# UNITED STATES PATENT AND TRADEMARK OFFICE

APPLICATION NO.	FILING DATE	FIRST NAMED INVENTOR	ATTORNEY DOCKET NO.	CONFIRMATION NO.
10/029,071	12/21/2001	Takeshi Yagi	1113-017/MMM	5313
7590	03/30/2005		EXAMINER	
Ipsolon LLP 805 SW Broadway #2740 Portland, OR 97205			KIM, YOUNG J	
			ART UNIT	PAPER NUMBER
			1637

<b>Office Action Summary</b>	<b>Application No.</b> 10/029,071	<b>Applicant(s)</b> YAGI, TAKESHI	
	<b>Examiner</b> Young J. Kim	<b>Art Unit</b> 1637

**Fig. 1**

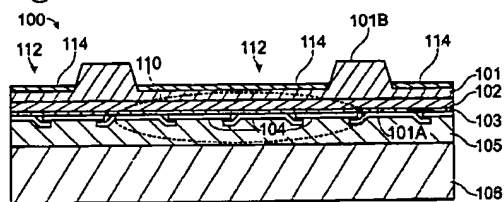
Claims 3 and 4 have been amended to include the limitation drawn to the semiconductor substrate having a thickness of 10 to 20  $\mu\text{m}$ , the thickness of which is measured from the organic molecules probe disposition region to the photoelectric converter, thus the distance between the two elements.

Figure 1 describing the claimed device is shown as below:

Section [0040] disclose that thickness “d1” is measured from surface “101B” to the bottoms of of the recesses “112”, wherein the bottoms of the recesses “112” is disclosed being organic molecule

probe disposition region for fixing organic molecule probes (e.g., the DNA probes).

Section [0038] discloses that pixels “110” each have a photoelectric converter.

Thus, while the specification contains a proper written description for the claimed thickness when measured between the surface “101B” to the probe disposition region “112,” does not have written description support for the instant limitation, wherein the thickness is measured between probe disposition region “112” and the photoelectric converter “110”. As no support for this limitation could be found in the instant specification, and since claims as originally filed did not contain support for this limitation, the claim amendment contains New Matter.
